Access Compliance Report

Public Rights-of-Way

(Curb Ramps)

Intersection ID: 4035	Main Street: BROWNE'S_FERRY_RD	Cross Street: REDBRIDGE_TL	Location: S
ADA ID: 08768BFC6D03	Ramp Type: Perp	Initial Pass/Fail: Fail	Overall Compliance: No
Severity Score: 8.75			
Codes/Mitigation Info/Possible Solution		Field Measurements/Component Compliance

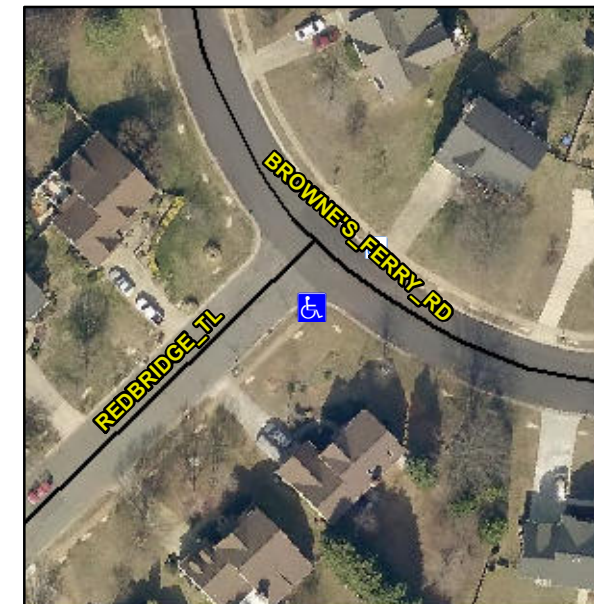
Not Found, R304.5.1

Compliance	Description	Data	Compliance	Description	Data
N/A	Ramp Length (in)	38.0	Yes	Ramp Slope (%)	7.2
No	Ramp Width (in)	46.5	Yes	Ramp XSlope (%)	1.5
N/A	Flare Type LT	N/A	N/A	Flare Type RT	N/A
N/A	Flare Slope LT (%)	N/A	N/A	Flare Slope RT (%)	N/A
N/A	Flare Traversable LT?	N/A	N/A	Flare Traversable RT?	N/A
N/A	Landing Length (in)	N/A	N/A	DWS Provided?	N/A
N/A	Landing Width (in)	N/A	N/A	DWS Contrast?	N/A
N/A	Landing Slope (%)	N/A	N/A	DWS Length (in)	N/A
N/A	Landing X Slope (%)	N/A	N/A	DWS Full Width?	N/A
N/A	Landing Curb? (Y/N)	N/A	N/A	DWS Offset (in)	N/A
N/A	Shared Landing?	N/A			
N/A	Gutter Ponding?	N/A	N/A	Gutter Slope (%)	N/A
N/A	Gutter Lip Ht (in)	N/A	N/A	Gutter X Slope (%)	N/A
N/A	Painted X Walk1?	No	N/A	Painted X Walk2?	N/A
	X Walk 1 Direction	To NE		X Walk 2 Direction	N/A
N/A	X Walk 1 Width (in)	N/A	N/A	X Walk 2 Width (in)	N/A
	X Walk 1 Slope (%)	1.0		X Walk 2 Slope (%)	N/A
	X Walk 1 X Slope (%)	11.0		X Walk 2 X Slope (%)	N/A

Remove & Replace Entire Ramp.
